Submission to the CNSC by the
Canadian Coalition for Nuclear Responsibility

Regarding the Darlington New Nuclear Project (DNNP)
and the documents provided in support of
siting one of four BWRX-300 reactors
at the existing Darlington NGS site

EIS Environmental Impact Statement
PPE Plant Parameter Envelope

Submitted March 20 2023

FIGURE 2.5 Comparison of atmospheric releases of noble gases for selected BWRs (left) and PWRs (right) in the United States. The units on the vertical scale are in gigabecquerels (GBq = 0.03 Ci). SOURCE: Data from the United Nations Scientific Committee on the Effects of Atomic Radiation (UNSCEAR).

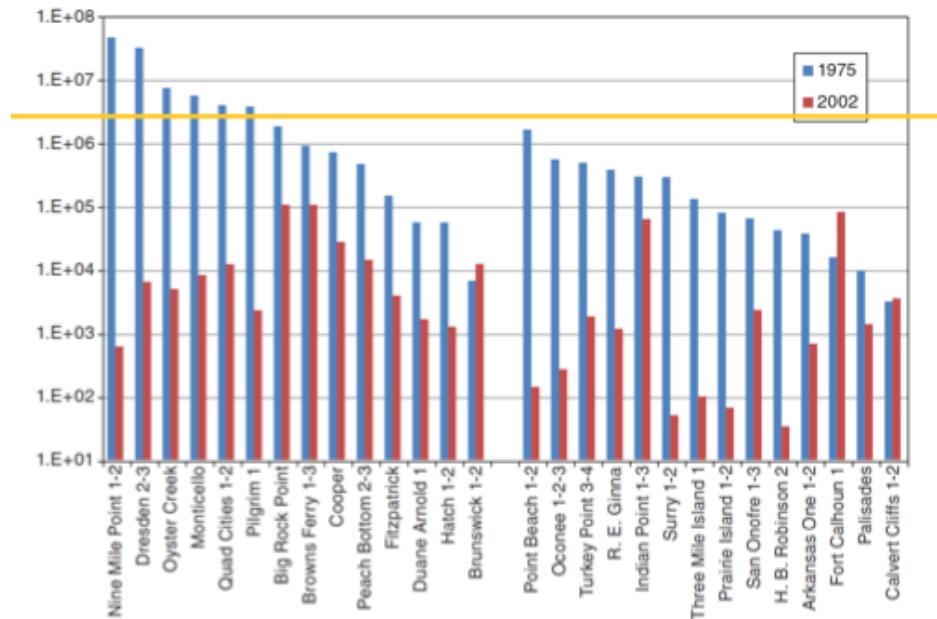
Let’s consider one of the numbers missing from PPE-2, the total atmospheric release of radioactive noble gases (last entries in tables 4.1 and 4.2). We know boiling water reactors tend to release more radioactive gases into the atmosphere than pressurized water reactors.

It is troubling that OPG would omit listing the total noble gas emissions in both tables of PPE-2. After all, the BWRX-300 is the only boiling water reactor ever considered in the context of this pre-licensing process.

Figure 2.1.1-2: Darlington Nuclear Generation Station and Darlington New Nuclear Project Lands

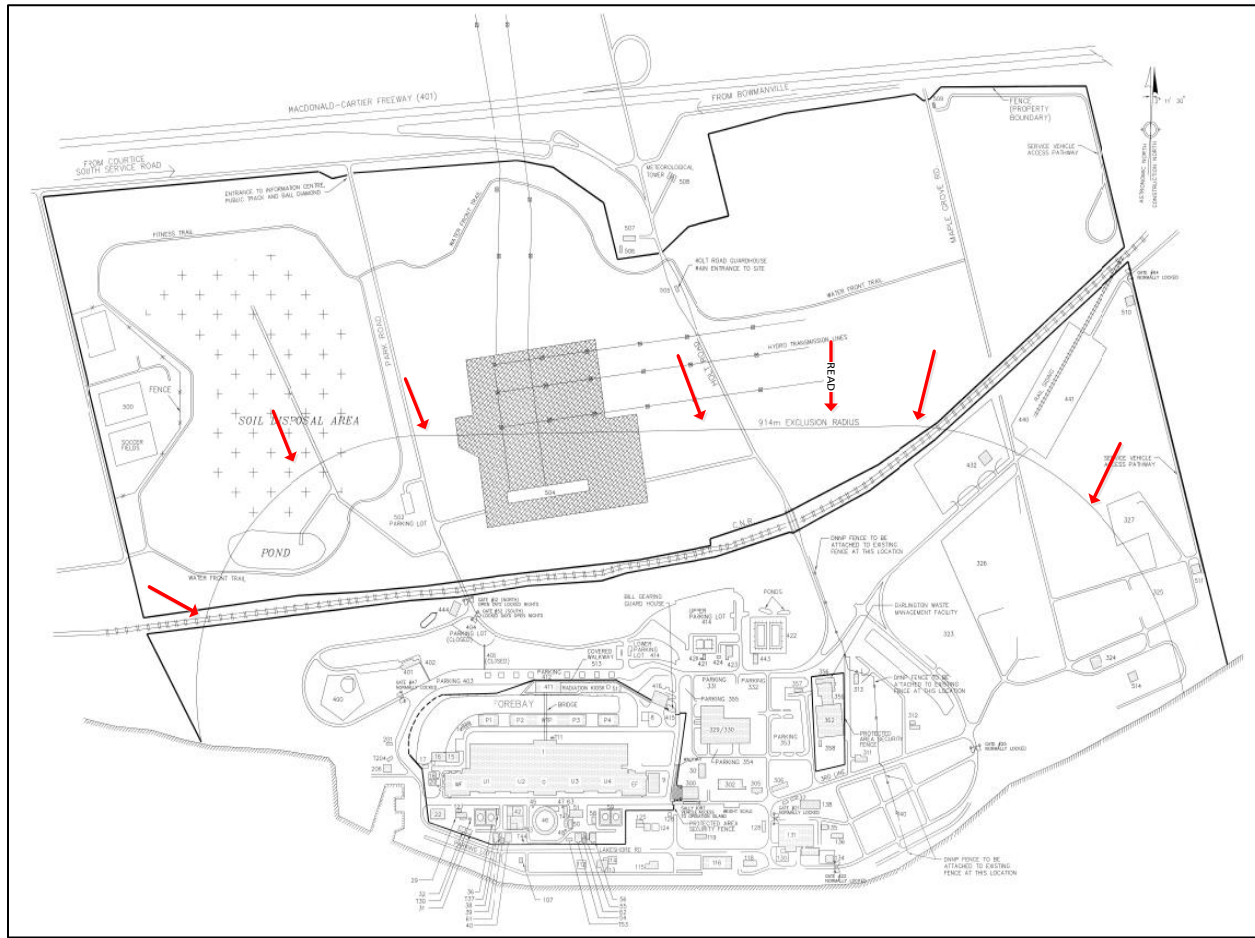
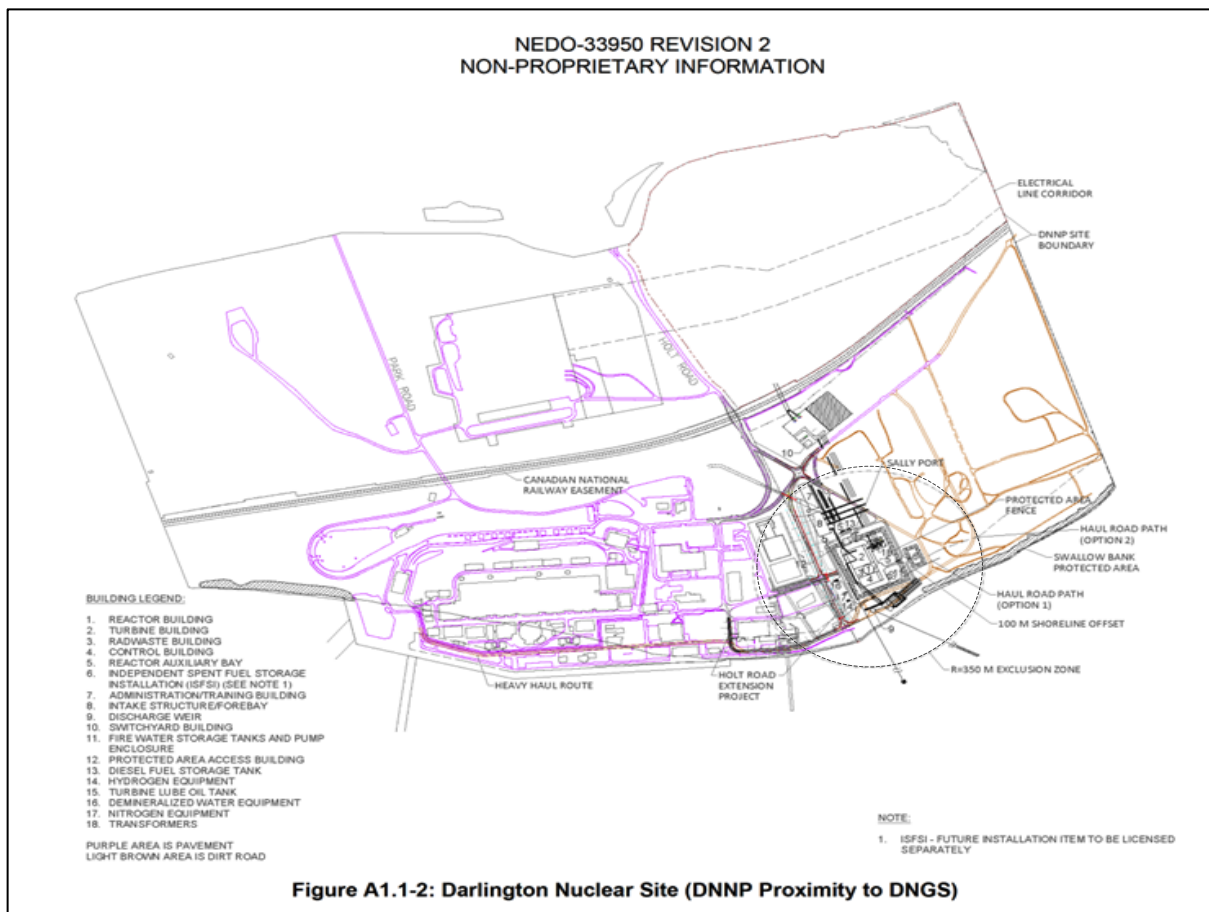
Then there's the geometry. Until the government of Ontario nixed the original DNNP project nine years ago, it was assumed that DNGS A & B (8 large reactors total) would sit side by side. The exclusion zone was designed to accommodate all eight reactors.

In these two images, the dotted lines indicate the boundary of the exclusion zone. The first image is from 1978, the second is from the 2012 Darlington Safety Report.

In each of these two diagrams, green circles represent the boundary of the exclusion zone.

Figure 2 : The 1978 Exclusion area boundary based on two 4 unit stations. Station B space now taken by dry storage.

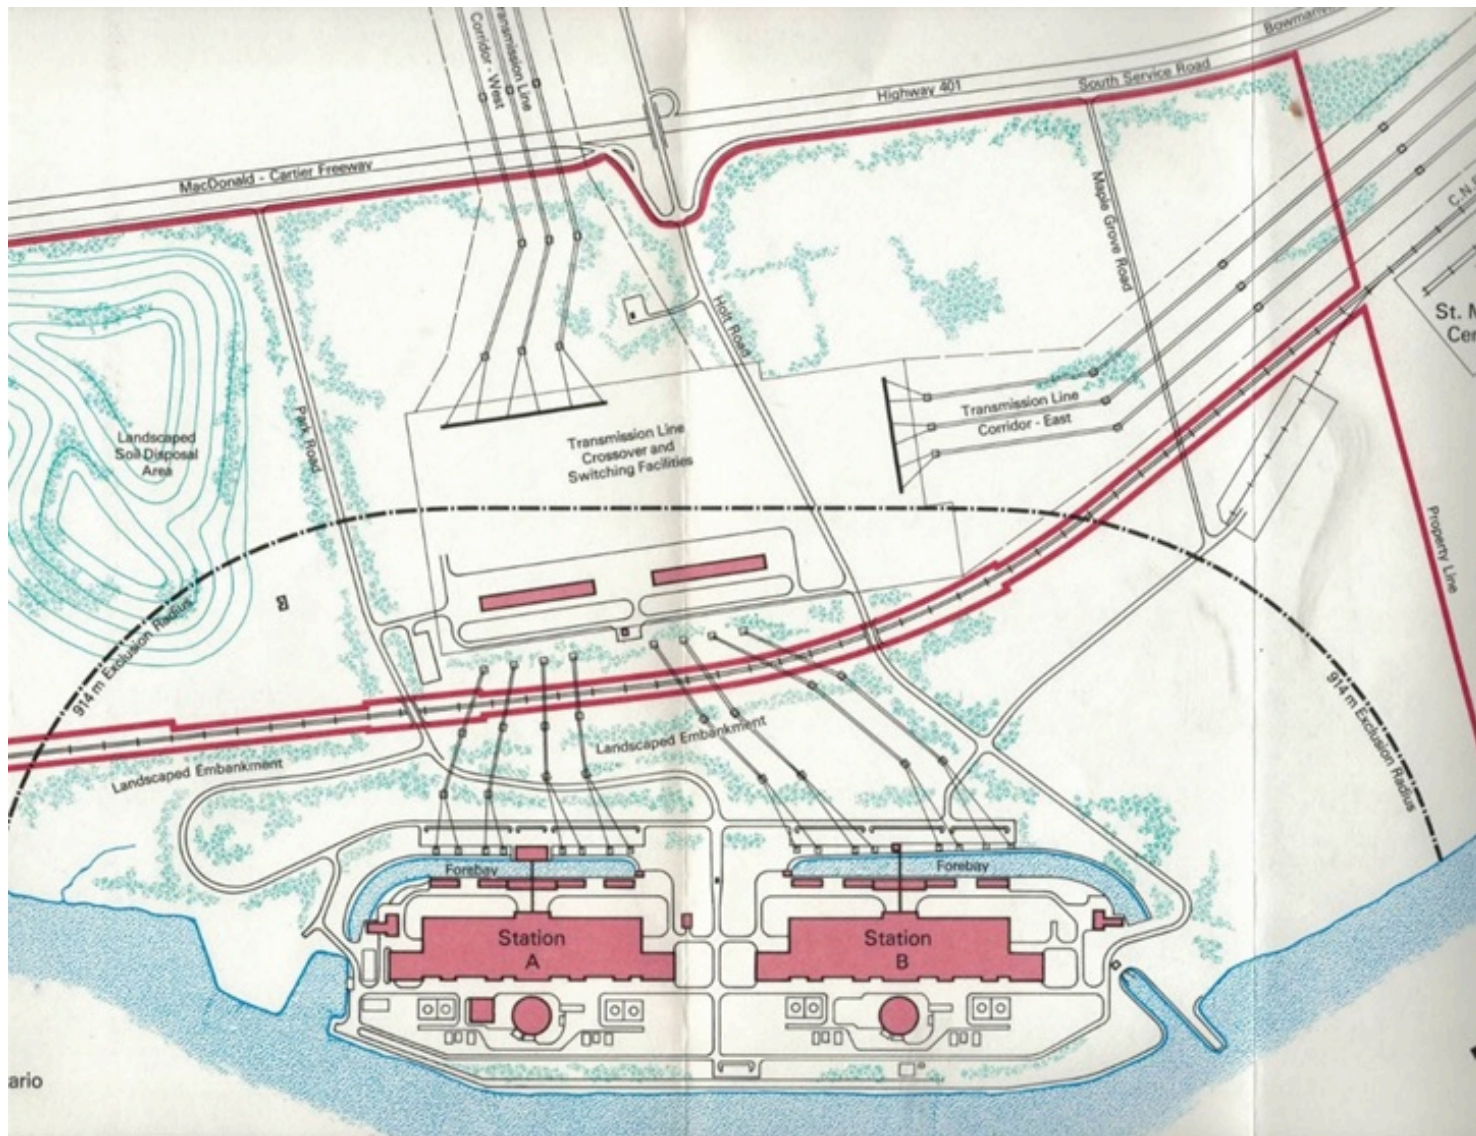
The Darlington 1000 yard (914m) wide exclusion zone taken from end of the reactor building footprints was a copy of what the US NRC had for their older reactors and the Canadian utilities were able to show to AECB then that it was sufficient for their benign operational release estimates compared to the so called Derived Emission Limits from operational releases and from extensive and conservatively stylized 'design basis' accidents they did consider. The original 1978 Exclusion area boundary was based on the plan of building two identical 4-unit CANDU stations DNGS-A and DNGS-B. The planned Station B was slowly abandoned and the designated space used for spent fuel dry storage that was not envisioned in the original design of the two reactor station complex, as a permanent storage solution for fast accumulating after ~10 years in the spent fuel pool wet storage was never found. AECL and OPG scrambled then to design dry storage solutions.

As Darlington B idea was abandoned over the years, the space that was to be used for that 'B' station was used for an extensive field of dry storage industrial buildings. The exclusion zone remained the same, (Figure 3) as was illustrated in the Darlington 2012 safety report and perhaps even later.

Figure 3 : DNGS Exclusion zone remained the same for at least 34 years as again so represented by OPG in 2012 Darlington Safety Report.

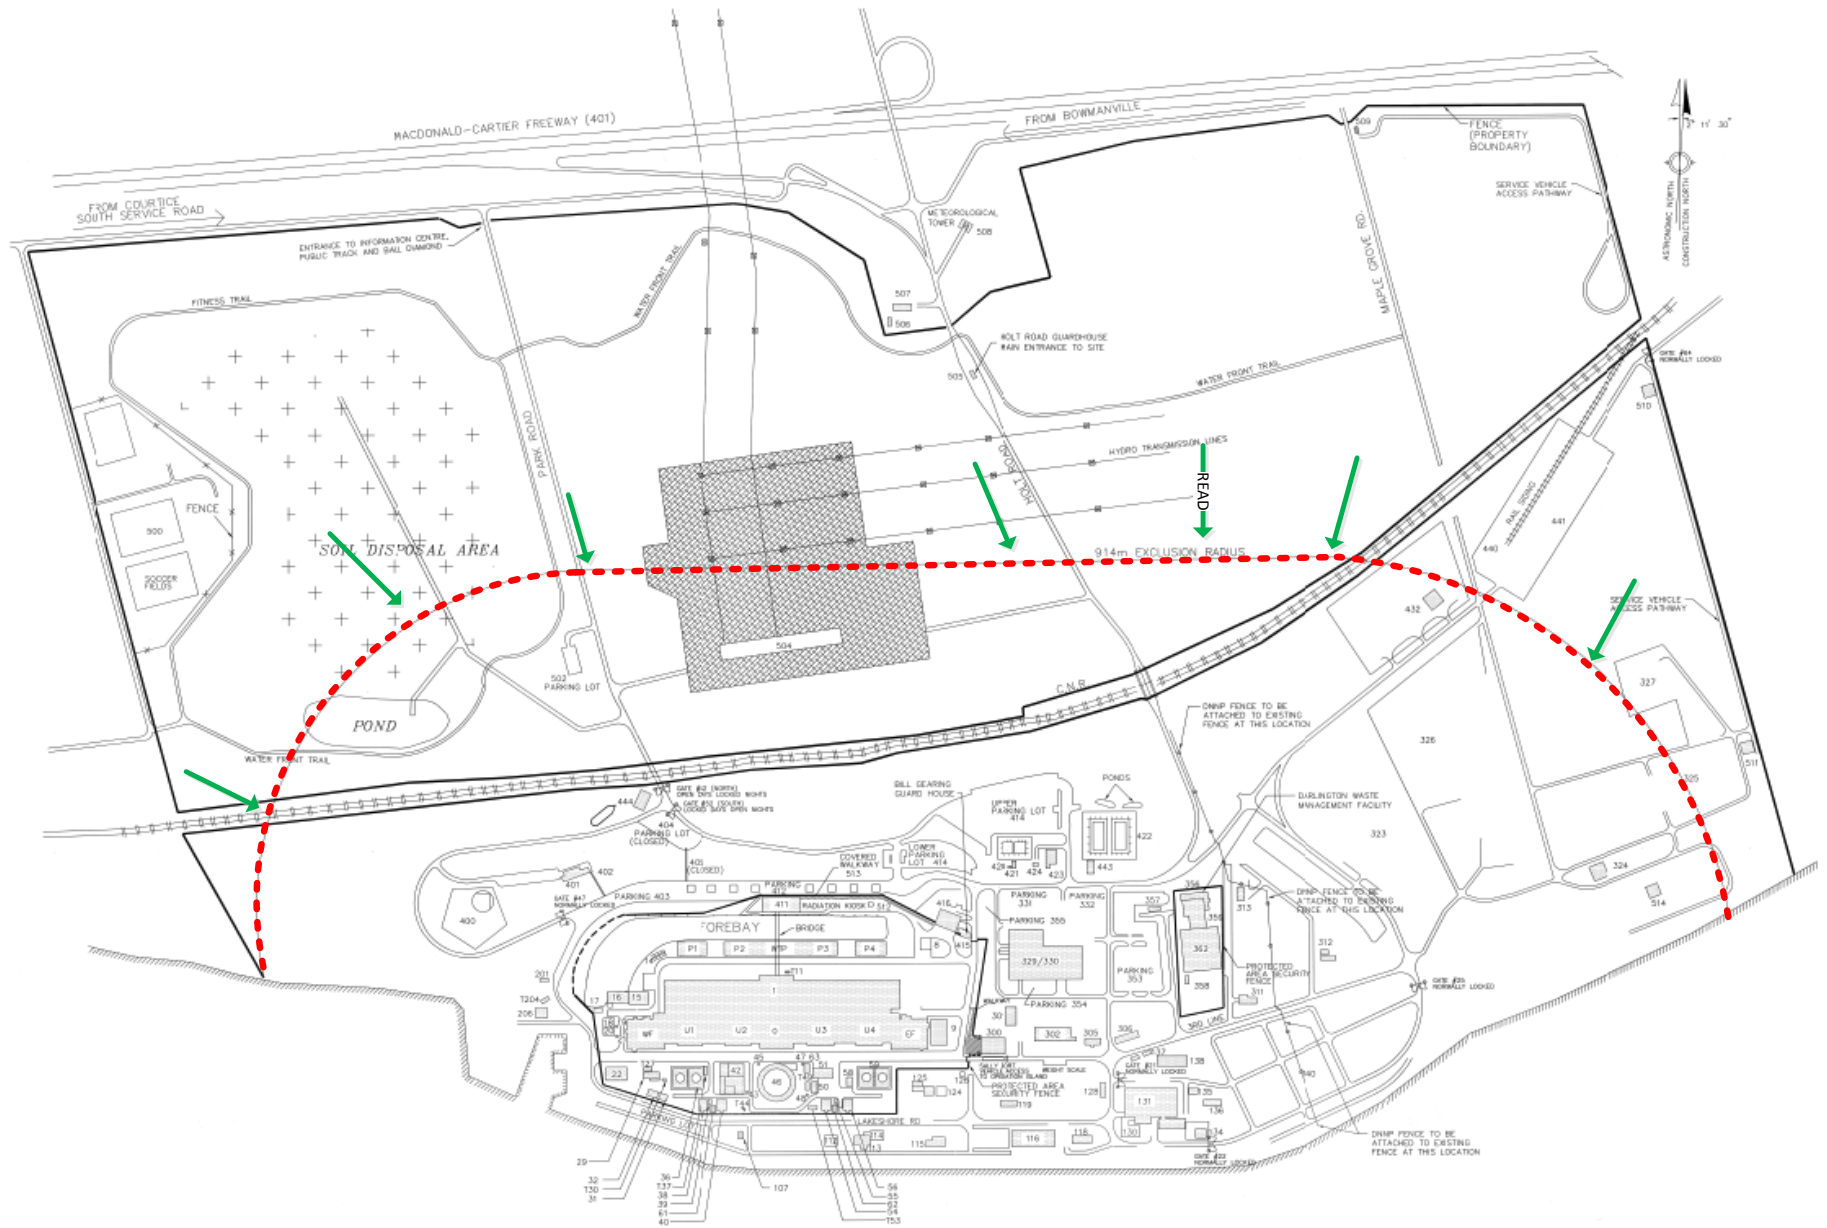
Then suddenly for us who follow developments in the nuclear industry, and inexplicably, in the 2022 application for an extension to operating license for the dry storage facility the exclusion zone for Darlington station was redrawn as in **Figure 4**. The 2023 public edition of the BWRX safety report, with area demarked for its operations in yellow mimicked the same diminished exclusion zone for Darlington CANDU reactors as in Figure 5. No exclusion area was added for the large dry spent fuel cask storage structures.

Figure 7: BWRX- switchyard is 58 meters from railway line. My house is at a greater distance from a line and shakes when trains go by relatively slowly.

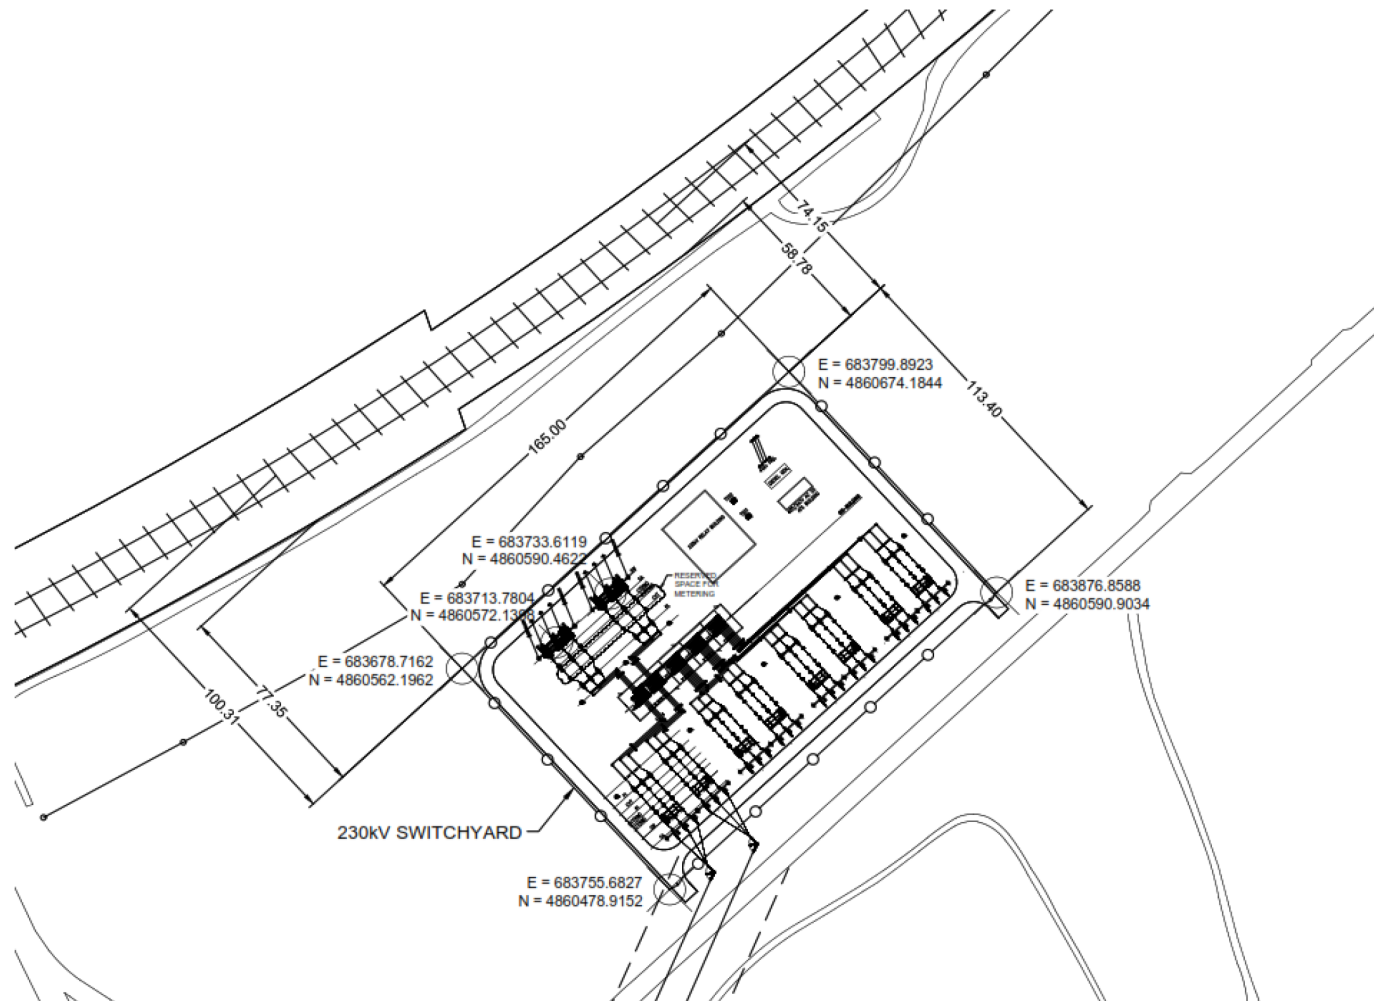
1. An active CN rail line bisected the lands designated now for the proposed new build (Figure 5)
2. The siting of the first unit was smack in the middle of the exclusion area for only the Darlington station that we had known for over 40 years (Figure 2 and Figure 3).
3. The siting of the first BWRX unit was next to the dry storage buildings and included parts of even the now reduced 914m EAB around DNGS-A.
4. The switchyard for the BWRX unit was a meter 58m from the active CN railway line.

Figure 14 : Sample results of operational releases of Tritium from US BWRs in 2008 from reference xx and PPE data for BWRX-300,

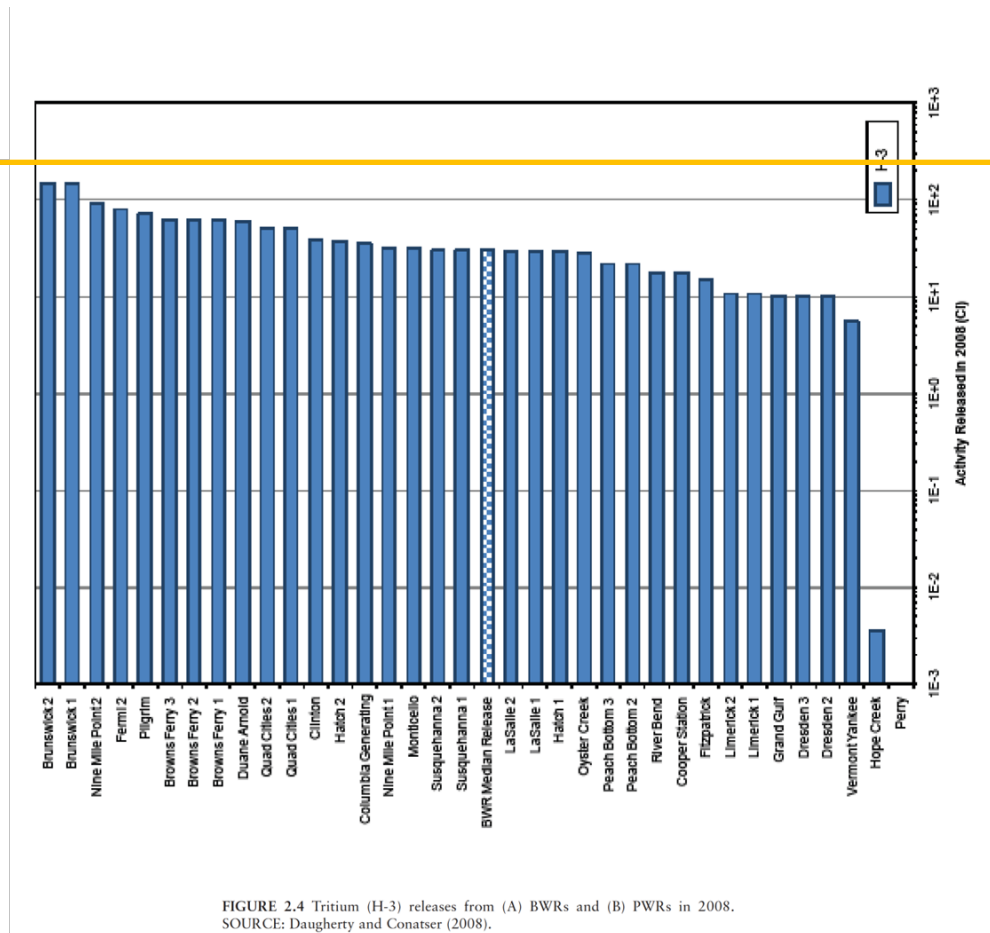
8. The process of arriving at the bounding value is not transparent as the data provided by each of the three vendors that dominate the information scape is not individually tabulated or referred to in a separate summary document for the design. That should have been an easy thing to do and with sufficient volume of information on the actual design, a proper way of verifying if the bounding data values were in context of ANY new design that may show up on the horizon layer, just as the BWRX-300 did, many years after the PPE was issued first. Observations on the specific features of a reactor design from which the bounding value was derived were not made.

9. The data set does not contain any information that would be necessary and be specific to the Darlington site where other operating reactors already exist. This includes data on Derived Emission Limits and actual emission history that would be added to that from new units.

We propose that the current PPE be not accepted as surrogate to anything and a renewed set of documents be prepared that details the actual data for BWRX-300 and issued for comments to me. It should include enough information on each of the reactor designs that were considered (as a summary design description with pictures and tables and references) and a much broader discussion of the chosen BWRX-300 design.

FIGURE 2.5 Comparison of atmospheric releases of noble gases for selected BWRs (left) and PWRs (right) in the United States. The units on the vertical scale are in gigabecquerels (GBq = 0.03 Ci). SOURCE: Data from the United Nations Scientific Committee on the Effects of Atomic Radiation (UNSCEAR).

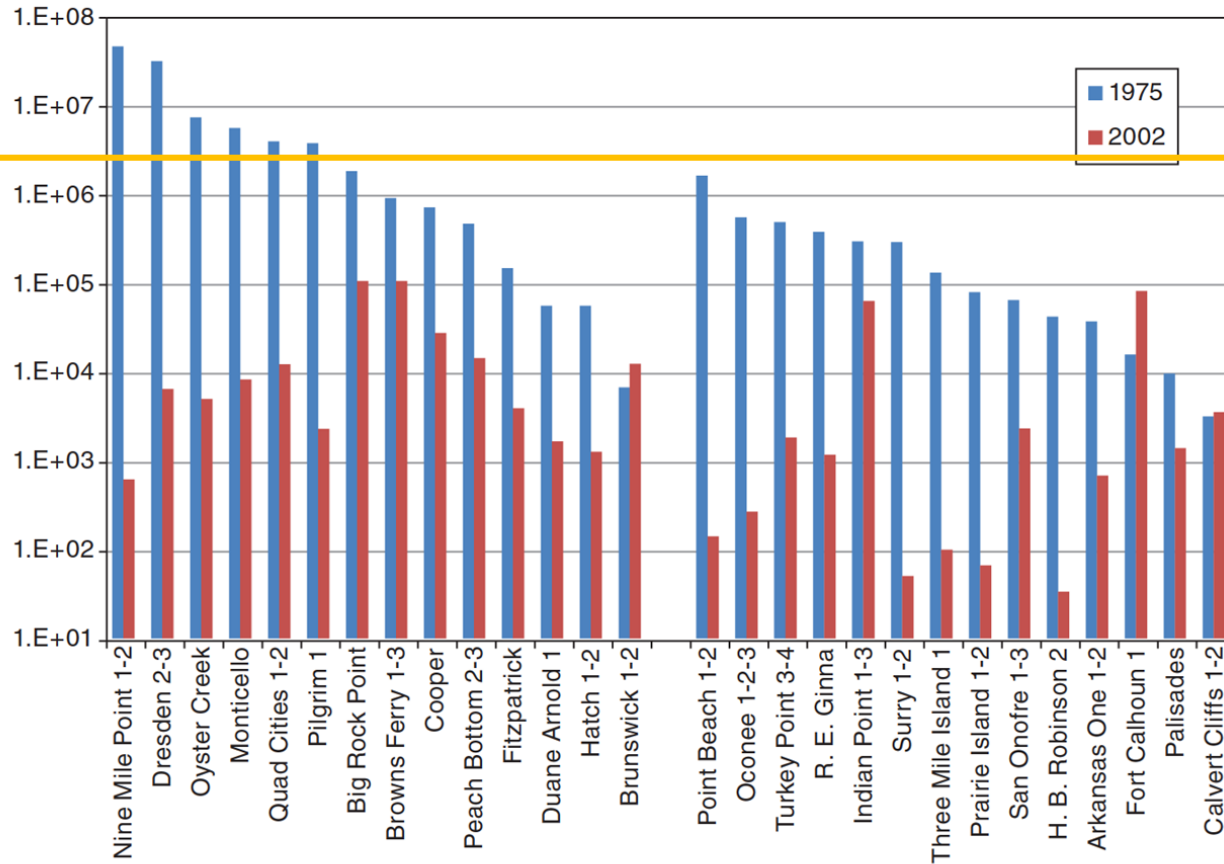
NOBLE
GASES
BWRX-300
3.67E6 GBq
